NUREG/CR-1672
SAI-324-82-PA
Vol. 4

Risk Assessment Methodology Development for Waste Isolation in Geologic Media

Technical Review of NUREG/CR-1636, Volume 4;
NUREG/CR-2324 and NUREG/CR-2343

Science Applications, Inc.

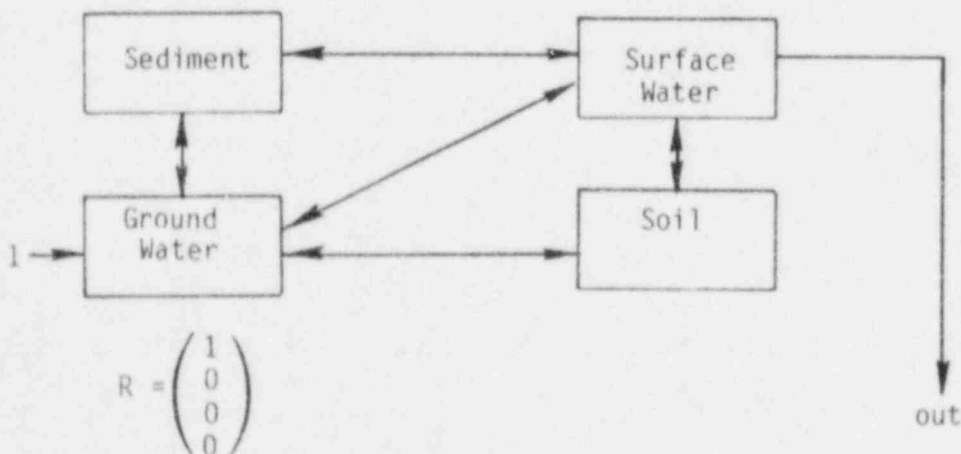
8. Pages 21 - 68. The captions associated with each of the figures are very confusing at first glance. It takes some work on the part of the reader to figure out what is going on. First of all, the reader must recall that the authors are describing a very simplified situation, namely the case involving one zone and one radionuclide. This is mentioned on the top of Page 4. Second the reader must recall the statement on the bottom of Page 17 which mentions the fact that each case involves a unit rate of input (one atom/year) in each subzone. All of this should be made very explicit. One way to do this is to include the following vectors in the captions of the figures: $R = [1, 0, 0, 0]$, $R^T = [0, 1, 0, 0]$, etc.
